DA2025/0077

DA SUBMISSION – 10-28 LAWRENCE STREET, FRESHWATER

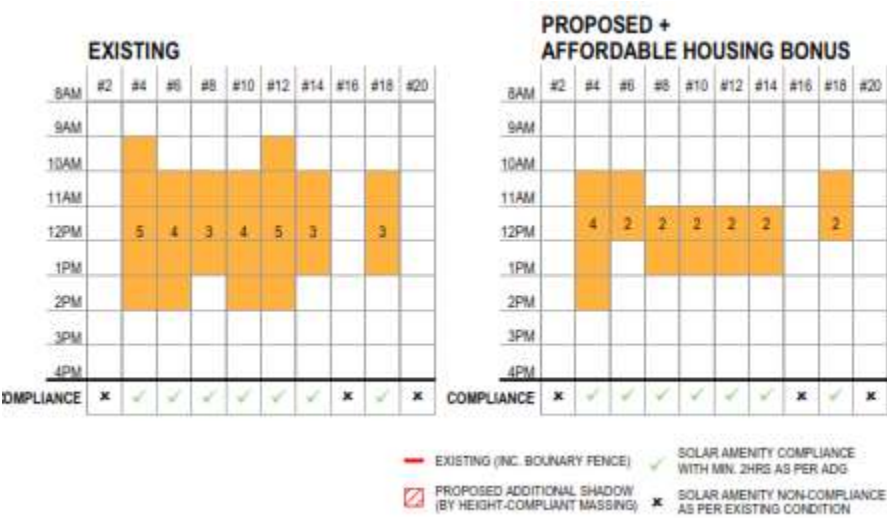
The Warringah DCP requires 72 retail parking spaces.

The development provides 62 spaces, 10 spaces short.

The submitted traffic report provides no reasonable argument for the shortfall in parking provided. Parking in Freshwater is very difficult, and the lack of sufficient parking will place further stress on the availability of street parking which will impact on parking for local residents. Providing additional retail GFA without sufficient parking is contrary to the provisions of the DCP and will impact on public parking in the area.
